VILLAGE OF PALATINE

PLAN COMMISSION AGENDA • NOVEMBER 2, 2021

**Architects Corner - Final Planned Development and
Reinstatement to allow for the 7-lot single-family residential
development of the vacant lots at 1939-1967 N.
Northumberland Pass (aka Architects Corner)**

ENGINEERING IMPROVEMENT PLANS
FOR
**ARCHITECTS CORNER
OF DUNHAVEN WOODS SUBDIVISION**
PALATINE, ILLINOIS
PLANS PREPARED
FOR
MIDWEST LIFESTYLE HOMES

UTILITY PLAN

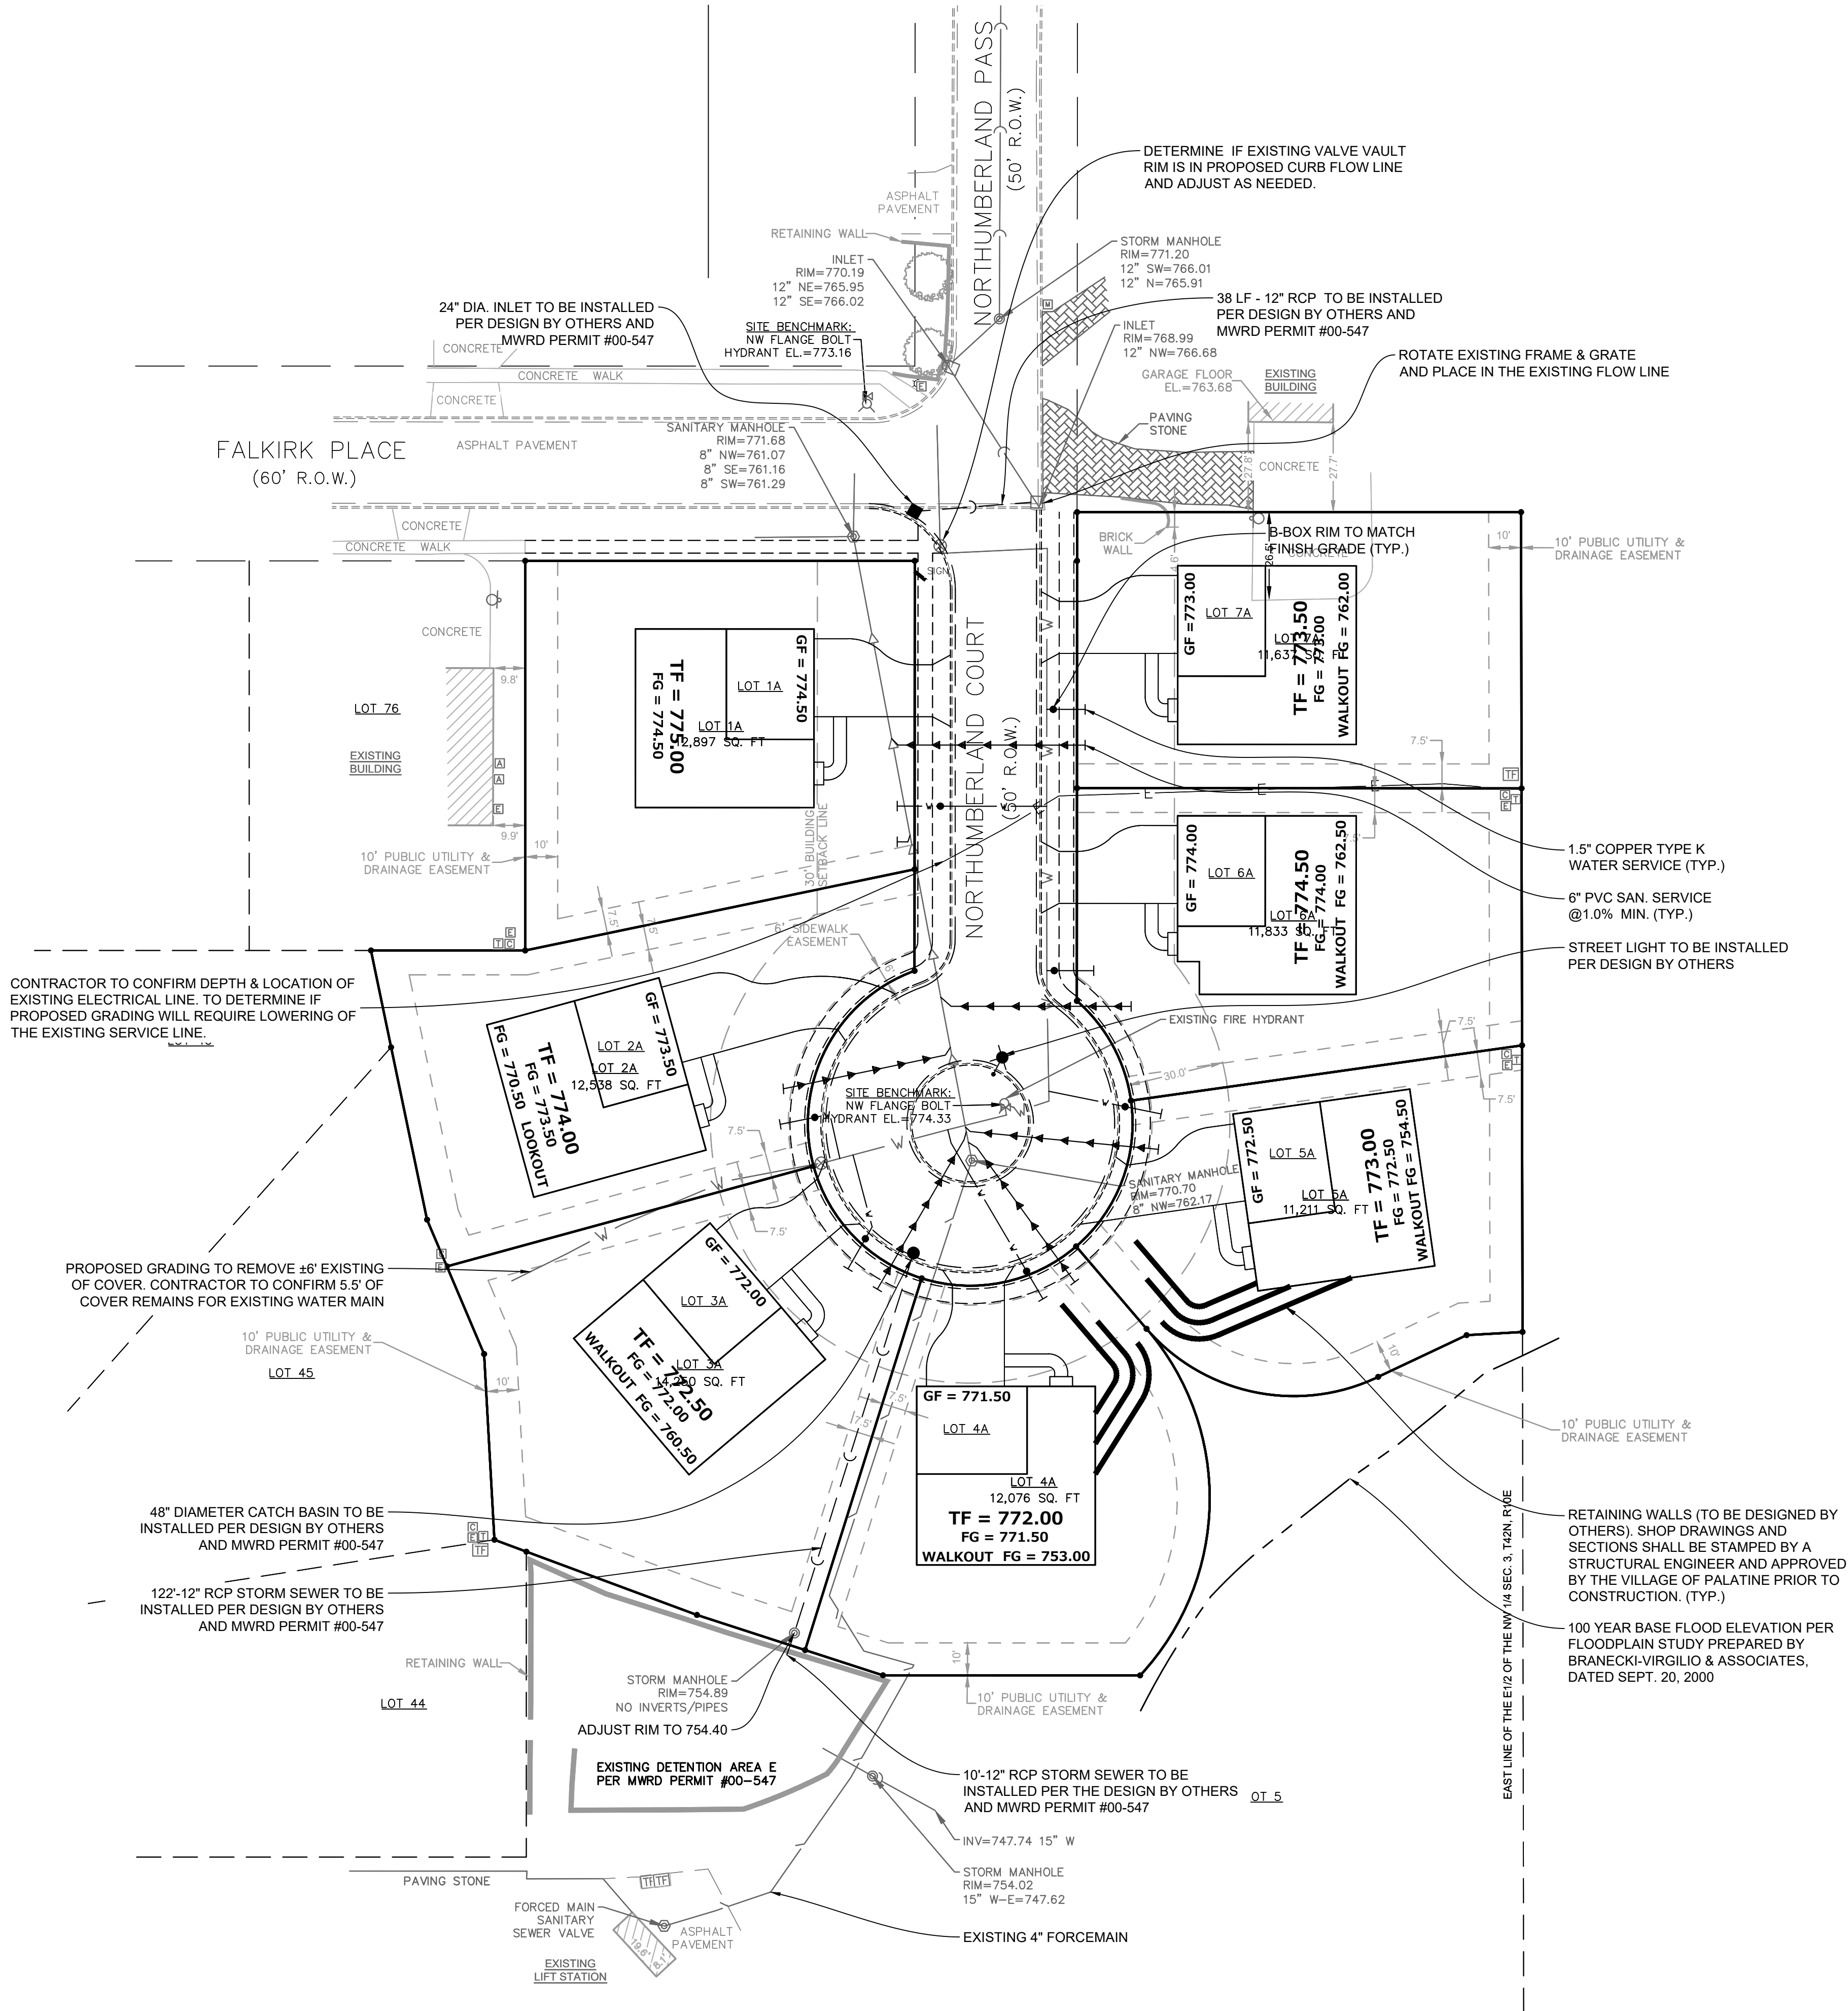
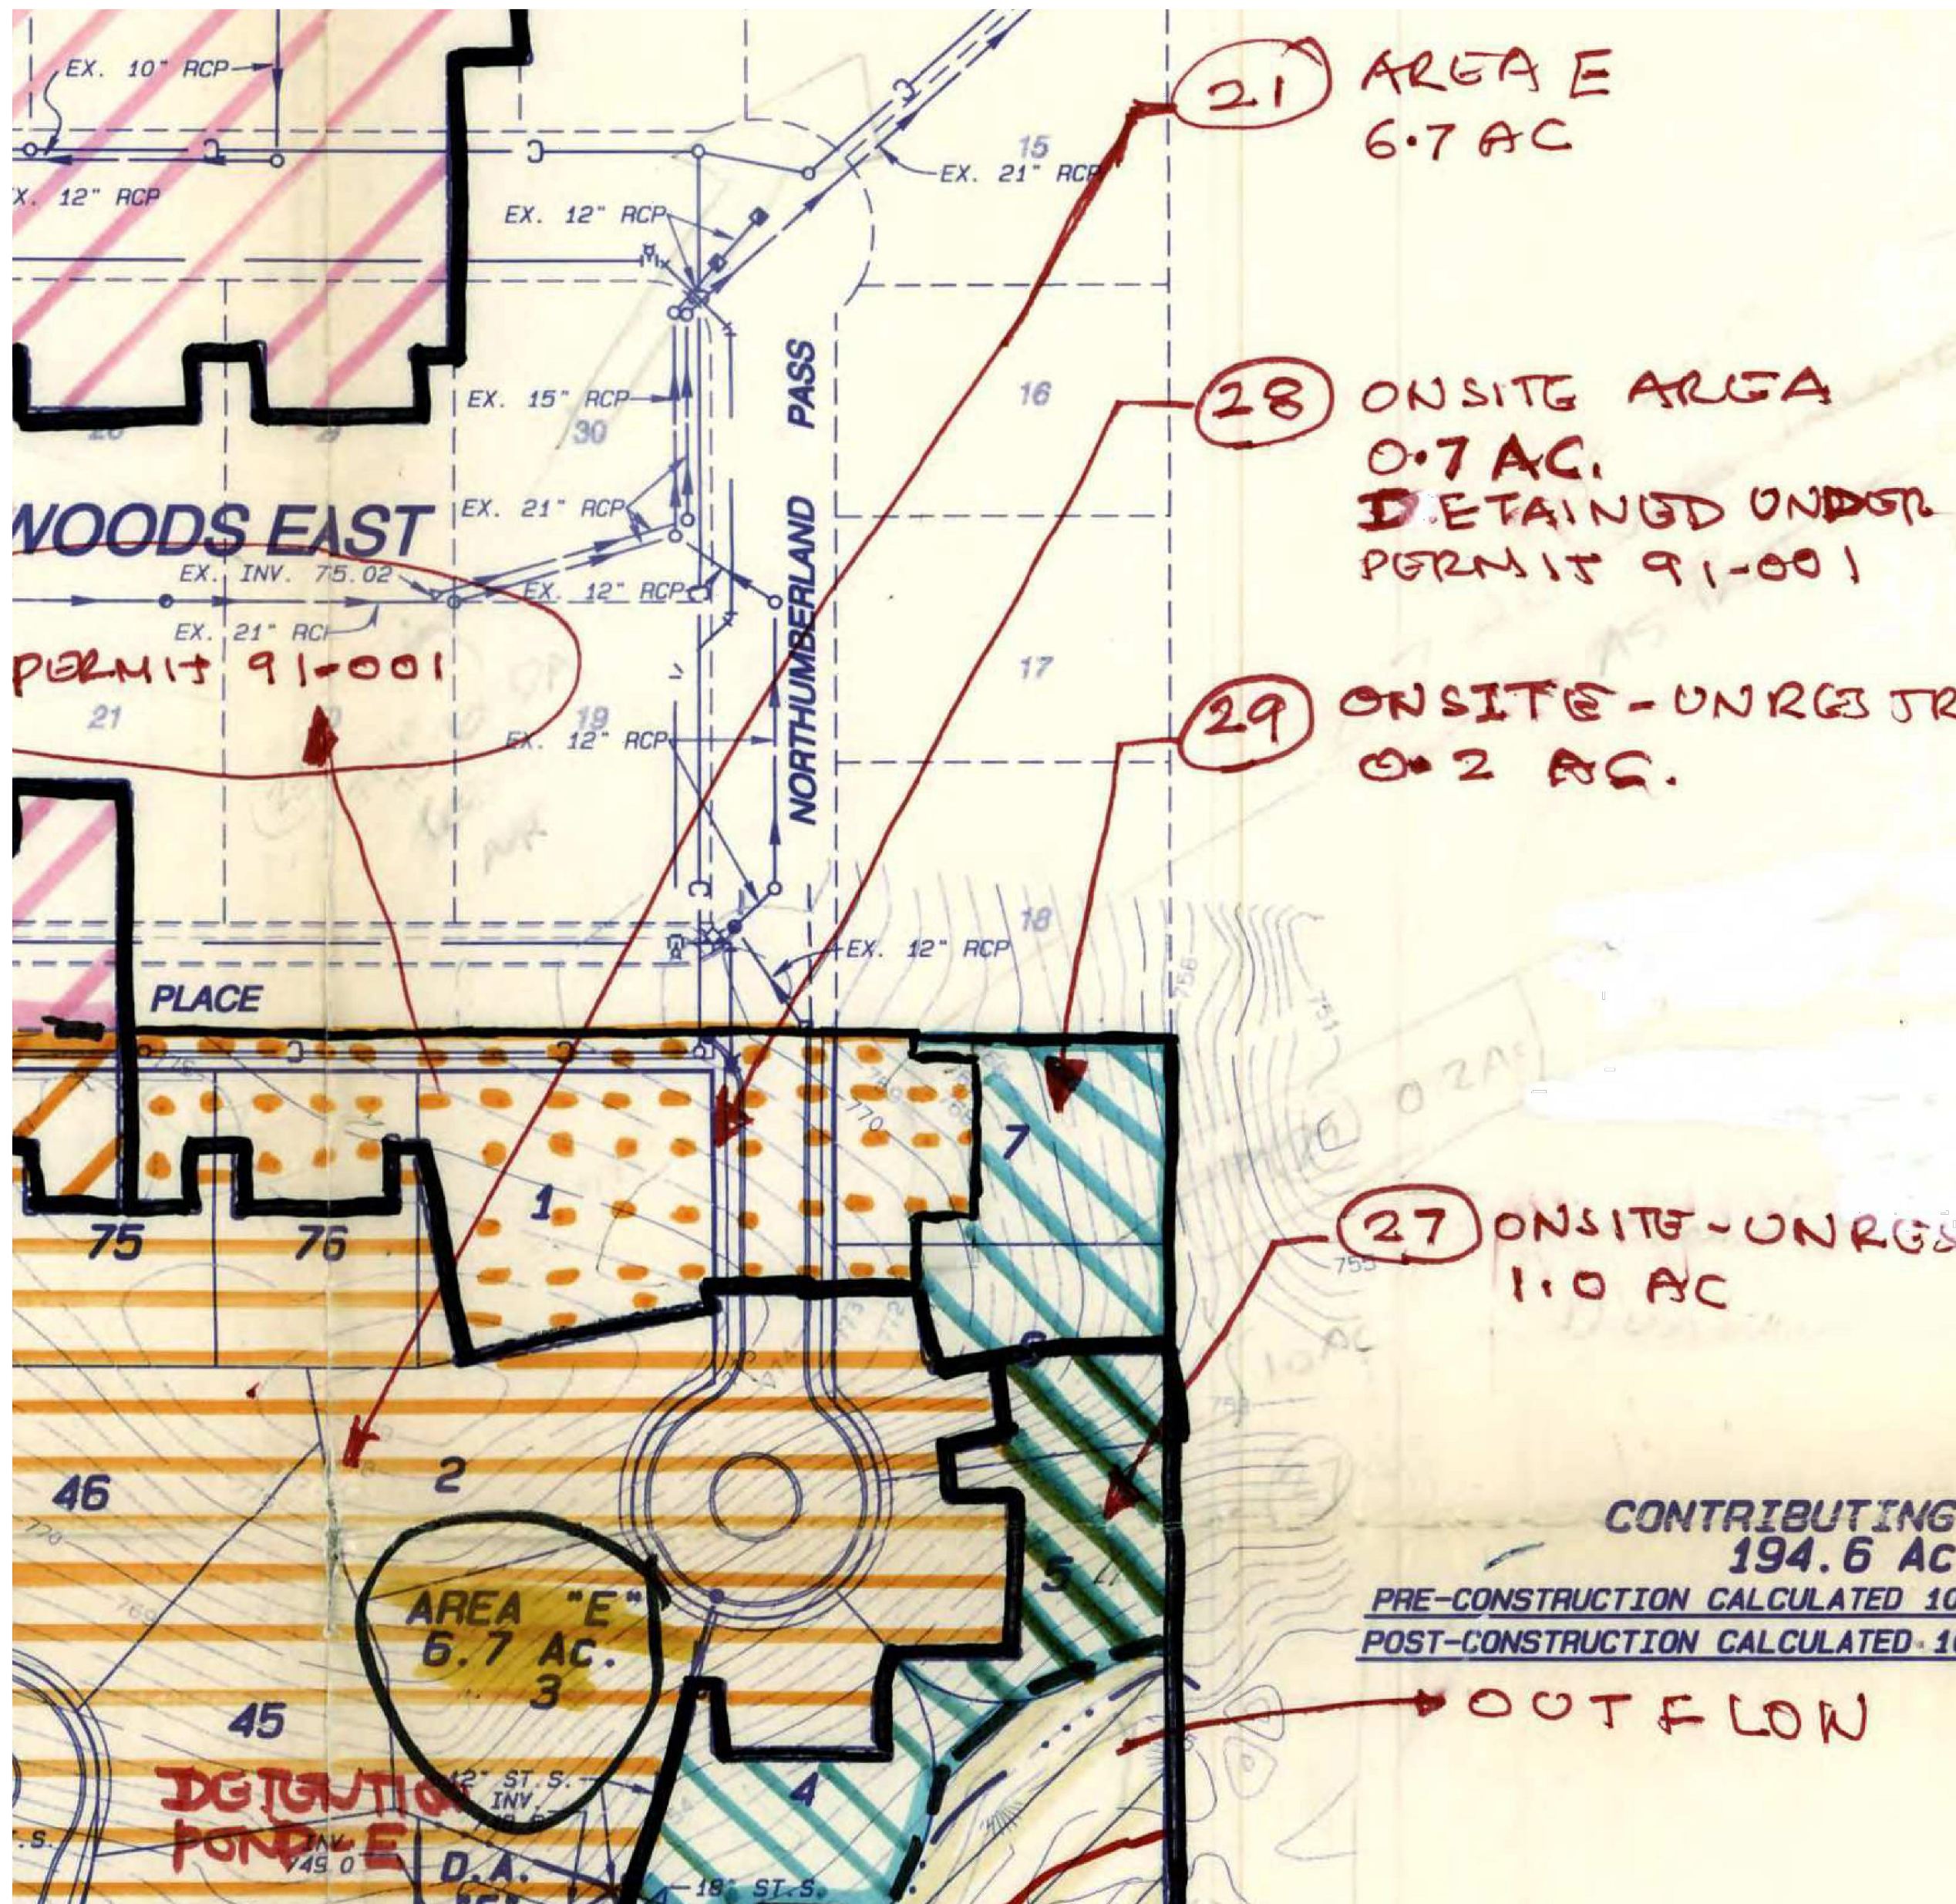
16. Prior to the issuance of a Site Development Permit, the engineering plans shall be revised regarding the storm sewer, as follows: All Curb inlet frames and grates shall be Neenah R-3278-AR with "open curb box" or an approved equal. The curb box shall have an opening of 5 inches minimum. Shall not be installed in a driveway apron.

17. Prior to the issuance of a Site Development Permit, the engineering plans shall be revised regarding the sanitary Sewer, as follows:
 - a. Contractor shall verify that no existing sanitary services currently exist

18. Prior to the issuance of a Site Development Permit, the engineering plans shall be revised regarding the water main

RESPONSE: The notes above have been added to Sheet C-5, Utility Plan, of the Engineering Improvements Plans, per your request.

RESPONSE: A note has been added to Sheet C-5, Utility Plan, of the Engineering Improvements Plans.

RESPONSE: A note has been added to Sheet C-5, Utility Plan, of the Engineering Improvements Plans.

RESPONSE: A note has been added to Sheet C-5, Utility Plan, of the Engineering Improvements Plans.

RESPONSE: A note has been added to Sheet C-5, Utility Plan, of the Engineering Improvements Plans.

RESPONSE: A note has been added to Sheet C-5, Utility Plan, of the Engineering Improvements Plans.

RESPONSE: A note has been added to Sheet C-5, Utility Plan, of the Engineering Improvements Plans.

RESPONSE: A note has been added to Sheet C-5, Utility Plan, of the Engineering Improvements Plans.
